Re: Reevaluation Report
Yellow Breeches Creek Re-Evaluation (S2-0250)
Permit No. E21-449
Upper Allen Township, Cumberland County

**HORIZONTAL DIRECTIONAL DRILL ANALYSIS
YELLOW BREECHES CREEK CROSSING
PADEP SECTION 105 PERMIT NO.S: E21-449
PA-CU-0203.0000-WX & PA-CU-0203.0000-WX-16
(SPLP HDD No. S2-0250)**

ORIGINAL AND REVISED HORIZONTAL DIRECTIONAL DRILL PLAN AND PROFILES

DATE:	2/8/2017
PROJECT NO.:	112IC05958
DESIGNED BY:	JB
DRAWN BY:	BH
CHECKED BY:	RS
COPYRIGHT TETRA TECH INC.	
ES-0.24A	
SHEET 0.24A OF 127

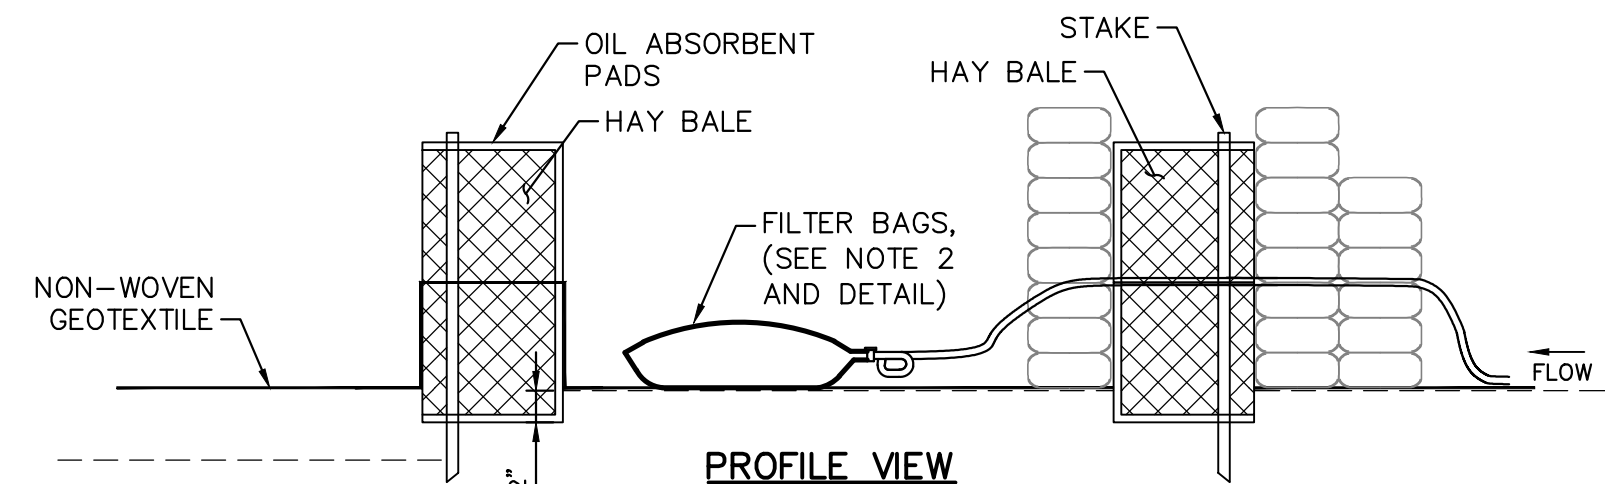
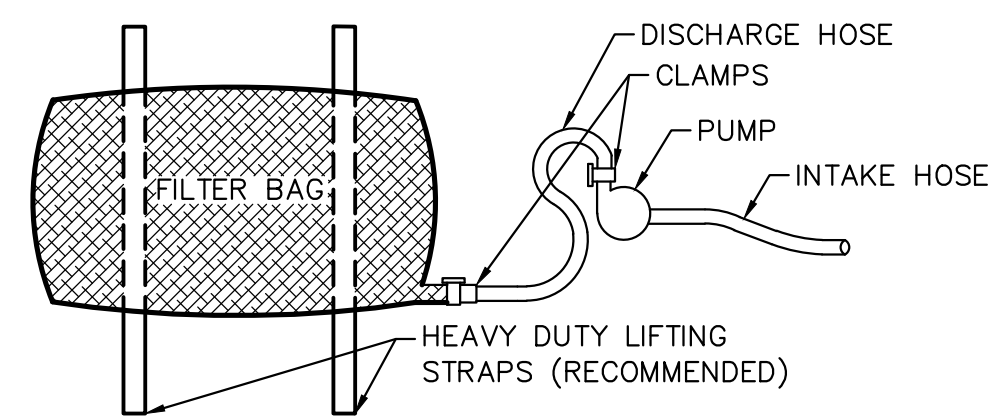
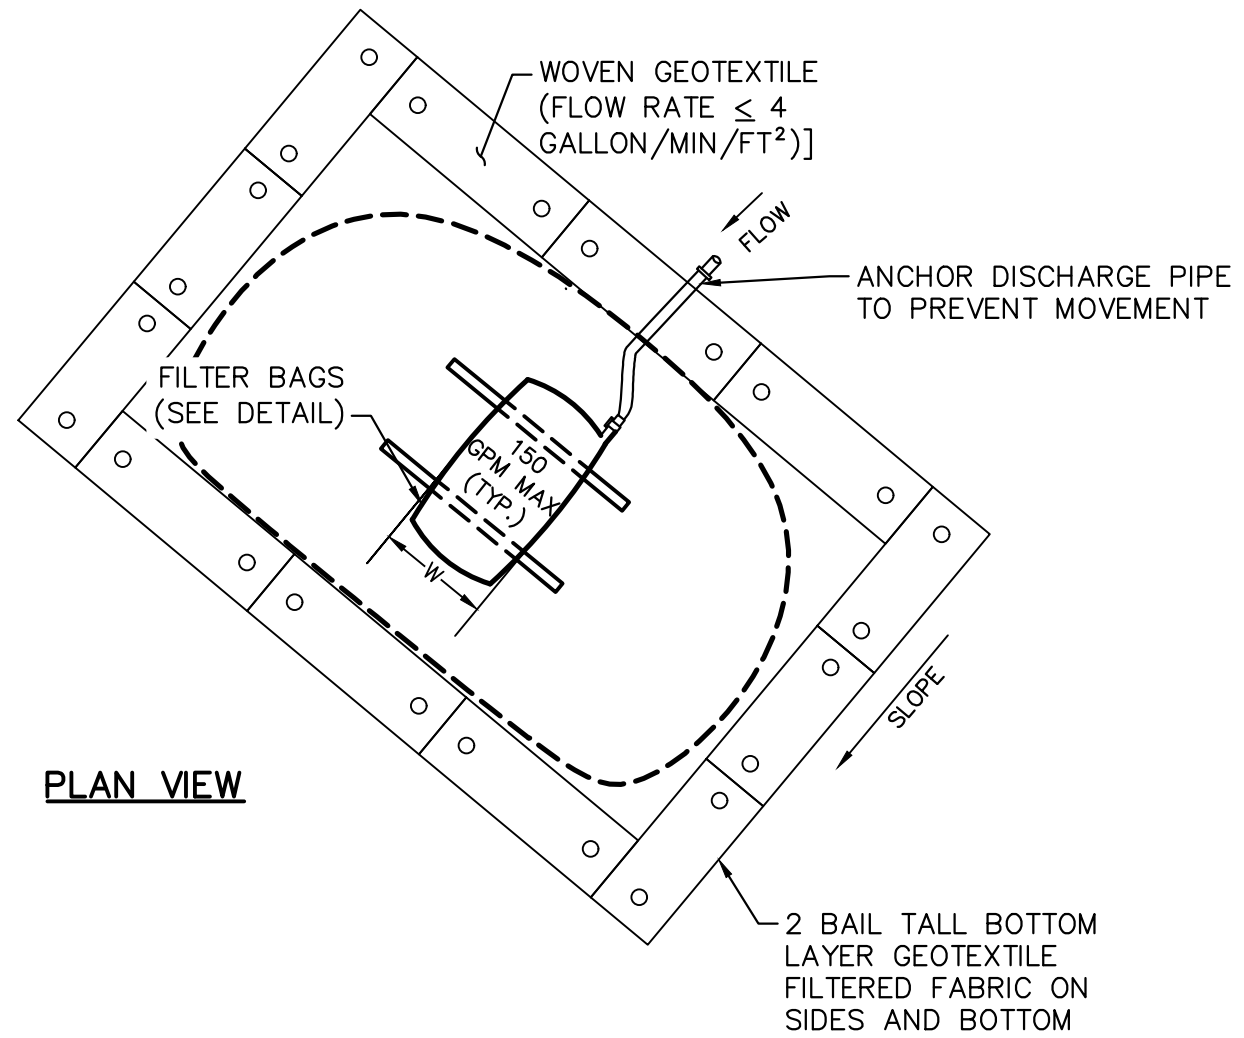
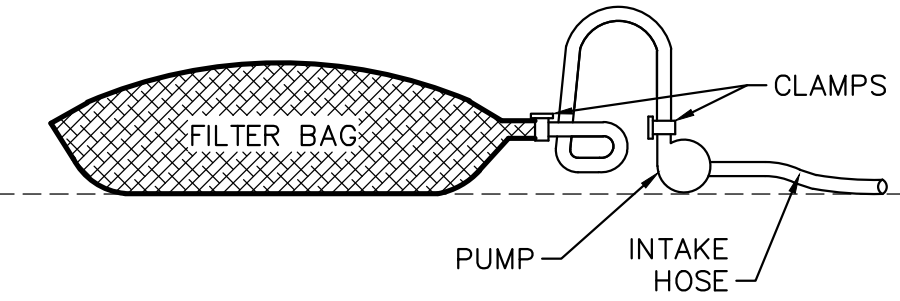
The Inadvertent Return section of the Reevaluation Report has been enhanced to specifically provide details on the plans for management of produced groundwater, and grouting of the HDD annulus after pulling of the pipeline segment into place if groundwater discharges persist after completion.

The attachments to the Reevaluation Report have been revised. Attachment 2 presents the revised E&S sheets detailing the water management control locations, and details on the discharge filtration structure. The original and revised HDD Plan and Profile are now in Attachment 3.

REVISIONS			
NO.	BY	DATE	REMARKS
1	RS	3/28/17	INCORPORATED THE SPECIAL CONDITIONS SET FORTH IN DEP'S CHAPTER 102 AND CHAPTER 105 PERMITS
2	RS	5/25/17	REDLINE REVISIONS
3	RS	1/23/18	ADDITIONAL DISCHARGE STRUCTURE DETAIL

Figure 1. Original 20-Inch HDD Plan and Profile

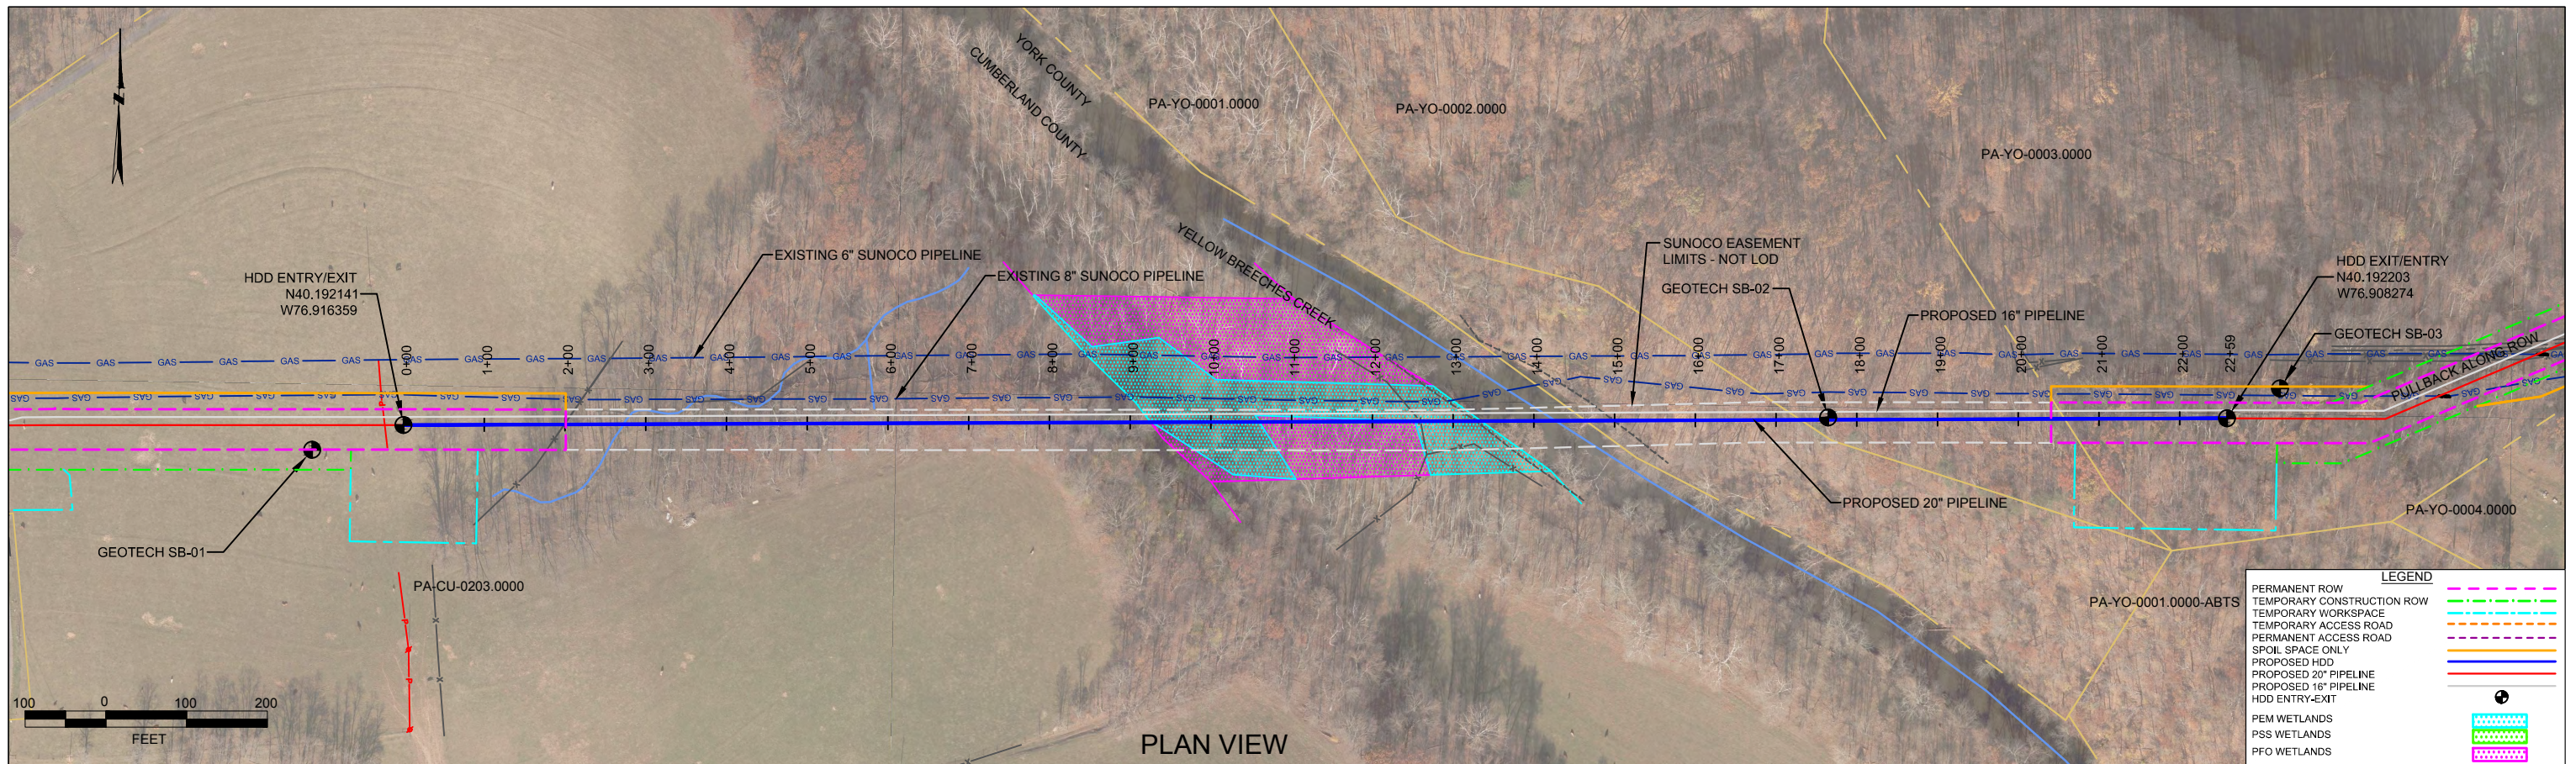
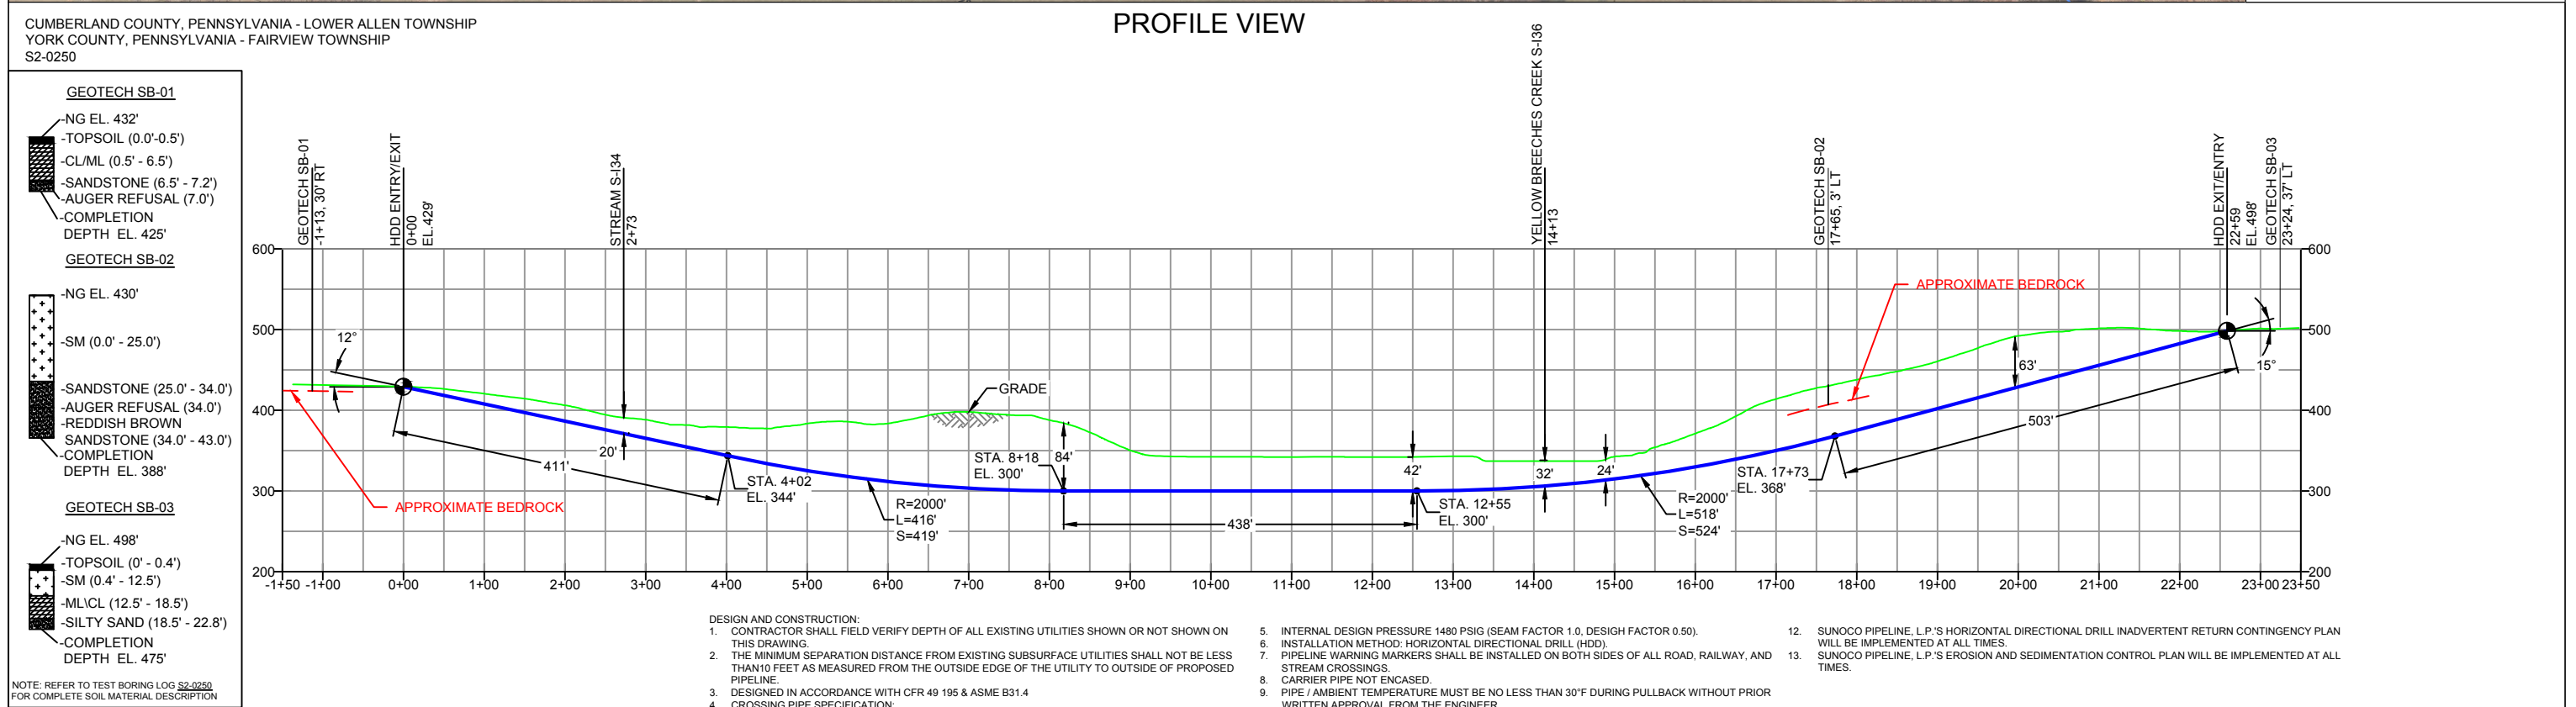
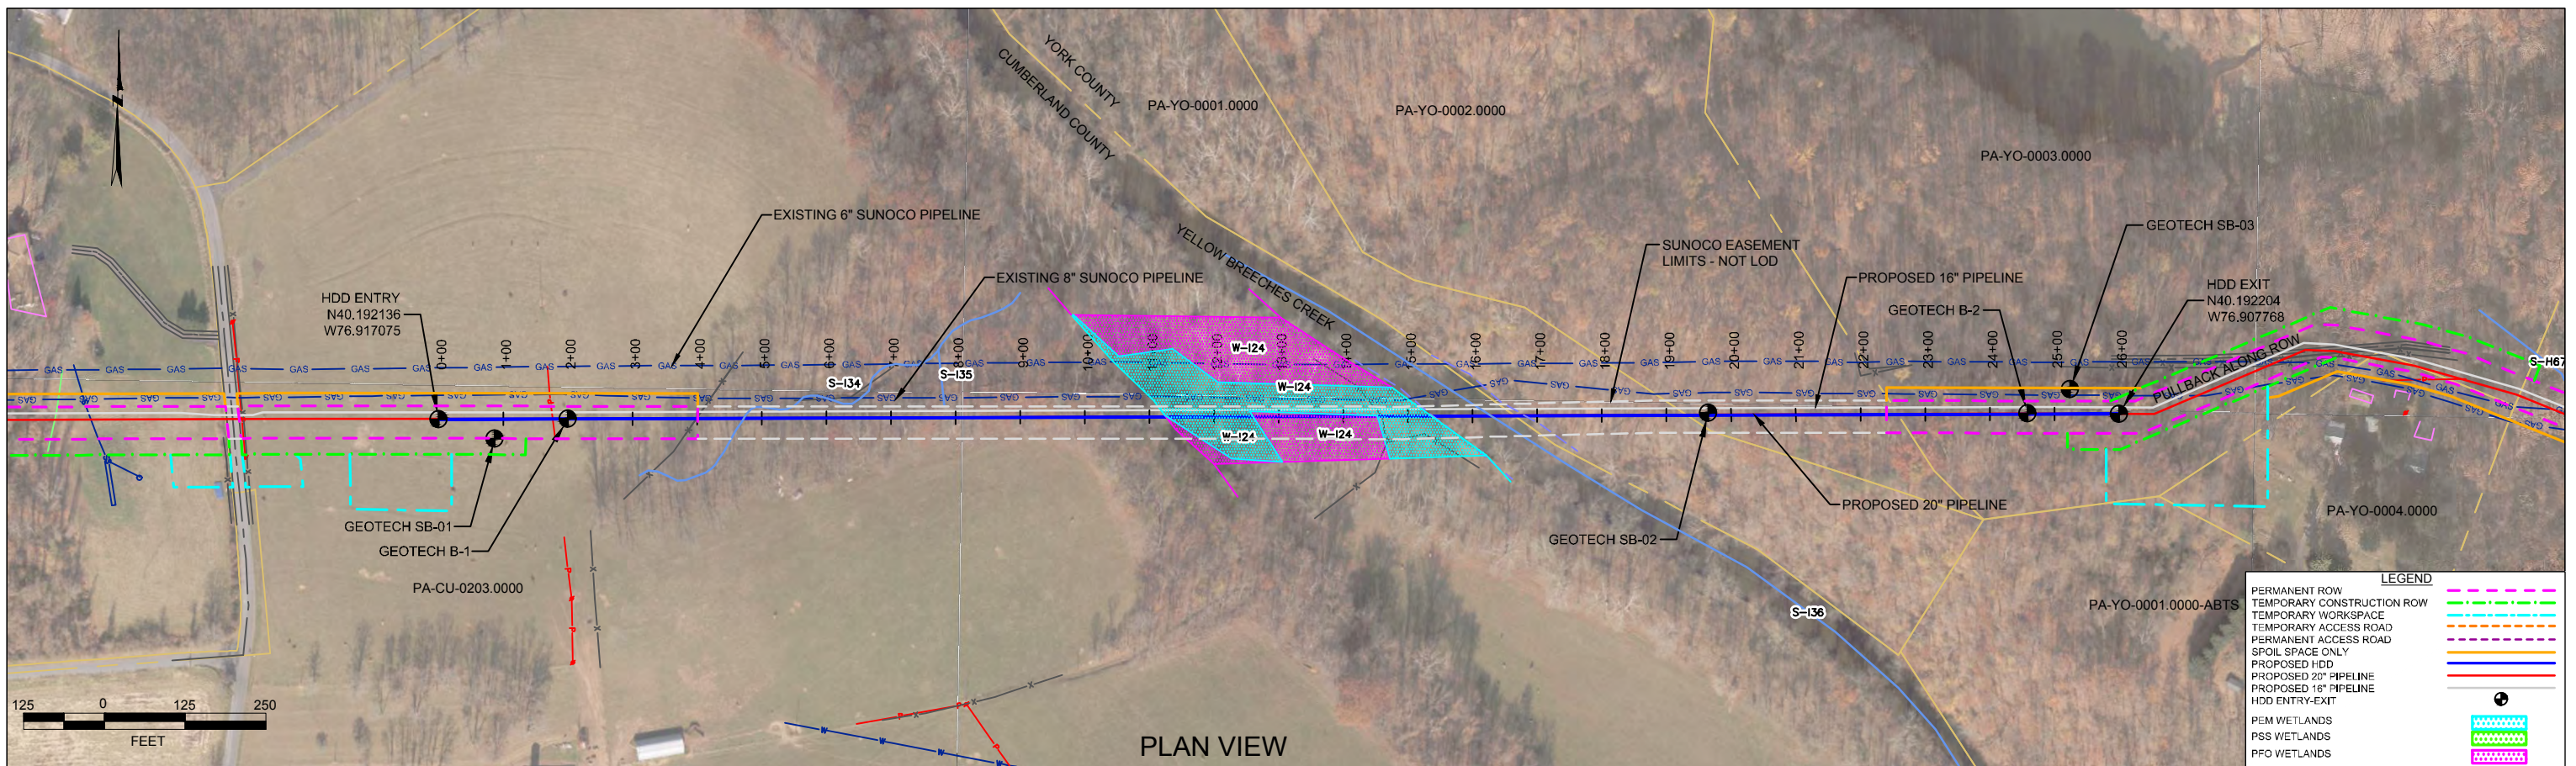
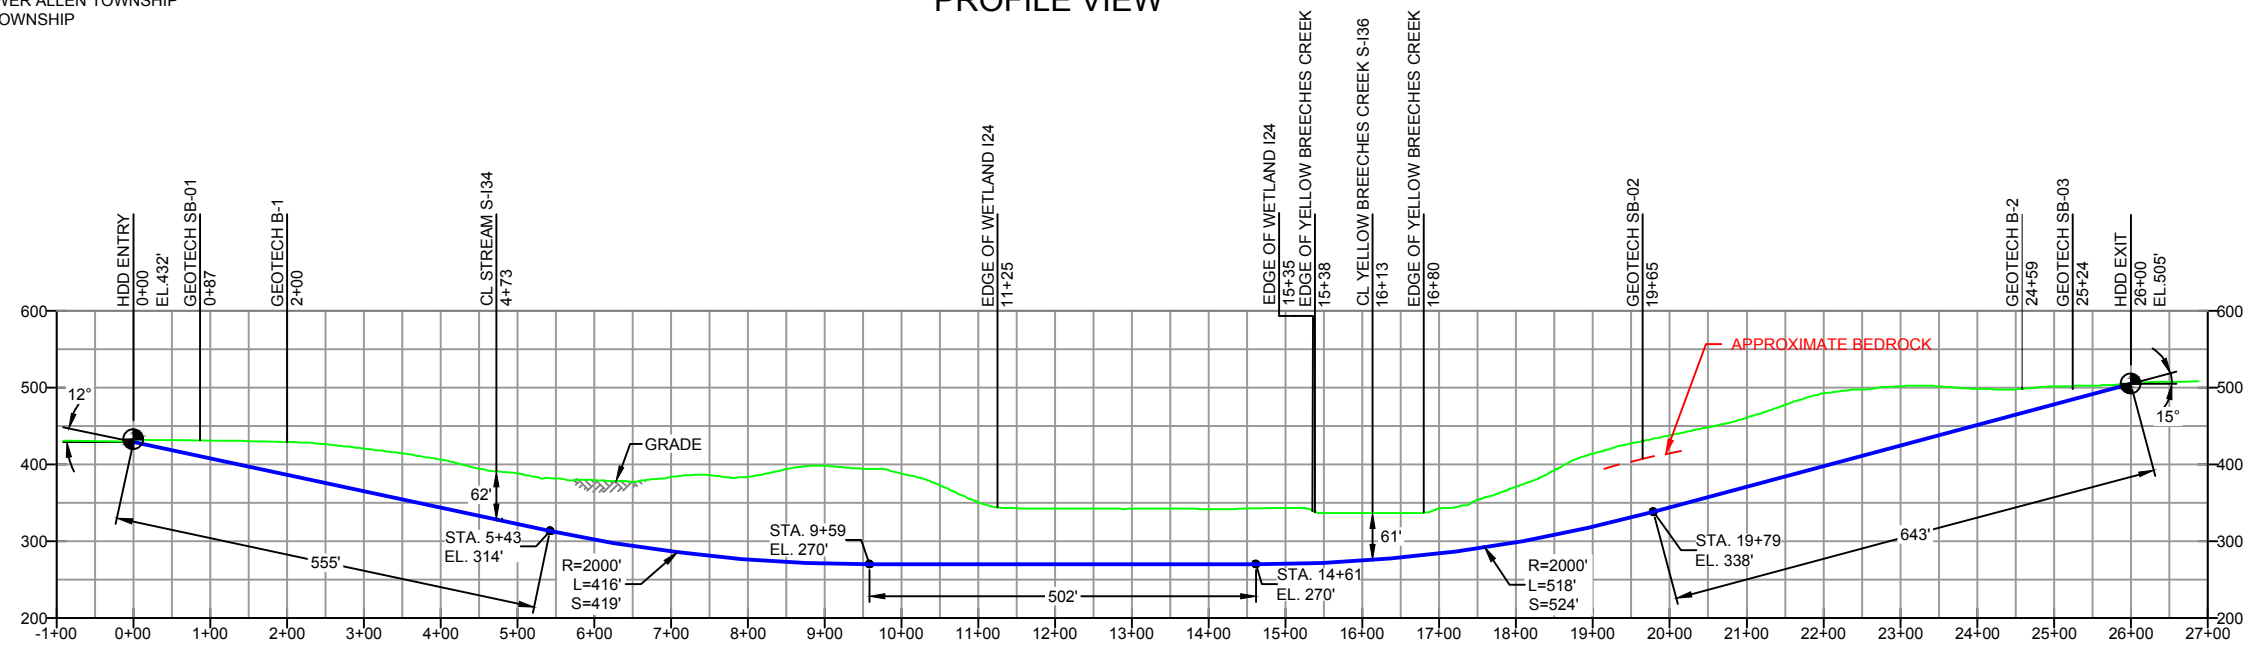
SPLP HDD consultants reviewed the HDD designs and geotechnical data for this area. Based upon this review, it was determined that the risk of IRs to waters overlying the HDD could be reduced by increasing the depth of the original permitted HDD profile. Additional geologic investigations have been completed and utilized in the redesign of the planned HDD. The redesign adjusts the HDD profile deeper to place the HDD pathway through bedrock having better structural integrity than a shallower profile and increase the overall length of the HDD due to pipe design requirements. A summary of the redesign factors is provided below.

It is SPLP's intent to modify the original profile design and to pursue a deeper and longer HDD profile. Figures 1 and 3 in Attachment 3 presents the original HDD plan and profiles. Figures 2 and 4 presents the revised HDD plan and profiles.
